Access Compliance Report

Public Rights-of-Way

Intersection ID: N/A	Main Street: NINA_DR	Cross Street: W_T_HARRIS_BV	Location: SW
ADA ID: A498C0F47973	Ramp Type: Para	Initial Pass/Fail: Fail	Overall Compliance: No
Codes/Mitigation Info/Possible Solution		Field Measurements/Component Compliance	
Severity Score: 12.5

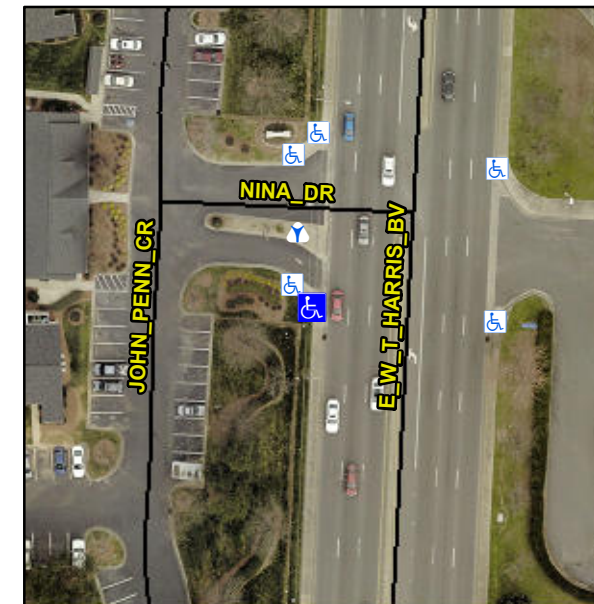
MEDIAN ACROSS W T HARRIS BV

R304.3.2

Compliance	Description	Data	Compliance	Description	Data
N/A	Ramp Length LT (in)	34.0	N/A	Ramp Length RT (in)	67.0
Yes	Ramp Width LT (in)	61.0	Yes	Ramp Width RT (in)	60.0
No	Ramp Slope LT (%)	11.6	No	Ramp Slope RT (%)	10.1
Yes	Ramp XSlope LT (%)	1.8	Yes	Ramp XSlope RT (%)	0.1
N/A	Landing Length (in)	N/A	N/A	DWS Provided?	N/A
N/A	Landing Width (in)	N/A	N/A	DWS Contrast?	N/A
N/A	Landing Slope (%)	N/A	N/A	DWS Length (in)	N/A
N/A	Landing X Slope (%)	N/A	N/A	DWS Full Width?	N/A
N/A	Landing Curb? (Y/N)	N/A	N/A	DWS Offset (in)	N/A
N/A	Shared Landing?	N/A			
N/A	Gutter Ponding?	N/A	N/A	Gutter Slope (%)	N/A
N/A	Gutter Lip Ht (in)	N/A	N/A	Gutter X Slope (%)	N/A
N/A	Painted X Walk1?	No	N/A	Painted X Walk2?	N/A
	X Walk 1 Direction	To E		X Walk 2 Direction	N/A
N/A	X Walk 1 Width (in)	N/A	N/A	X Walk 2 Width (in)	N/A
	X Walk 1 Slope (%)	1.4		X Walk 2 Slope (%)	N/A
	X Walk 1 X Slope (%)	0.8		X Walk 2 X Slope (%)	N/A
N/A	Ramp inside XWalk1?	N/A	N/A	Ramp inside XWalk2?	N/A

Remove & Replace Entire Ramp.
